NOTICE OF DATA INACCURACY

INSPECTION REPORT

Electrical Corporation:	Southern California Edison Company
Report Number:	PAD_SCE_SIS_20261007_1021
Date of Inspection:	October 7, 2026
City and/or County of Inspection:	Yucaipa, San Bernardino County
Inspector:	Samuel Isaiah
WMP Year Inspected:	2026
Quarterly Data Report (QDR) Referenced:	Quarter 2 (Q2)
Inspection Selection:	Energy Safety viewed the contents of the Q2 QDR and performed an analysis that resulted in the selection of the WMP initiatives and locations referenced in this report.
Relevant WMP Initiative(s):	8.2.1.1 – WCCP Covered Conductor
Inspection Purpose:	Assess the accuracy of Southern California Edison Company's QDR data, completeness of its work, and performance of WMP requirements.

Data Inaccuracy 1

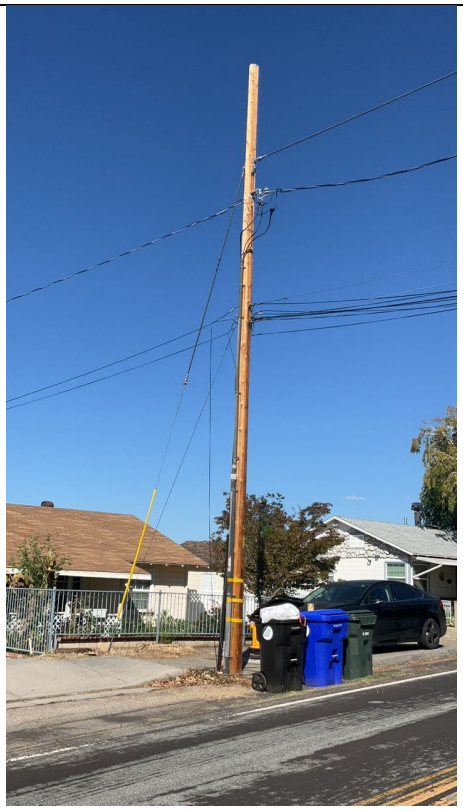
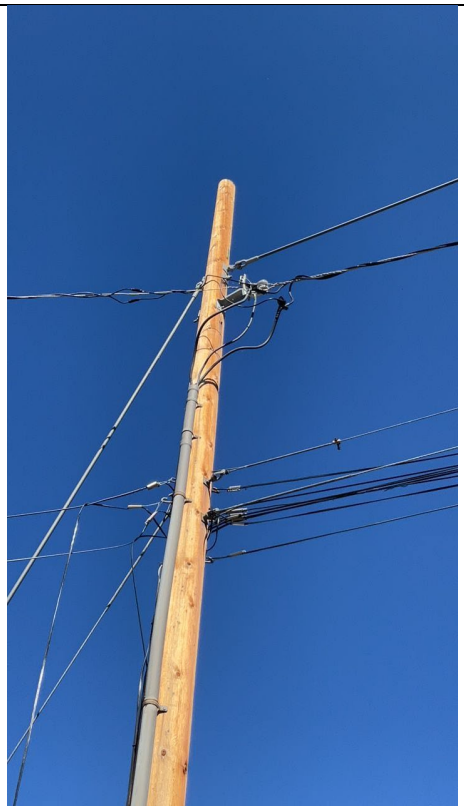
On Structure ID 4332416E, Grid Hardening ID TD2357977-4332416E at 12205-12317 Fremont St, Yucaipa, CA, 92399, USA, coordinates 34.0306693483214, -117.027275723204, the inspector observed that SCE failed to provide accurate data on covered conductor installation initiative. The inspector's observation is documented in Data Inaccuracy 1 photographs, which are attached to this report as Exhibit A.

1. SCE reported in the 2026 Q2 QDR that work on WMP initiative 8.2.1.1 – WCCP Covered Conductor was completed at this location.
2. In 2024, SCE informed Energy Safety that stub pole work does not count toward Covered Conductor WMP totals and would either identify or exclude these points in future QDRs. This data point did not contain an identifier and was not excluded.
3. No covered conductor was observed.

Asset Image 1: No covered conductor observed	**Asset Image 2**: No covered conductor observed

Within 30 days from the issuance date of this NODI, SCE should provide a response advising Energy Safety of corrective actions taken or planned to remedy the identified data inaccuracy or inaccuracies.
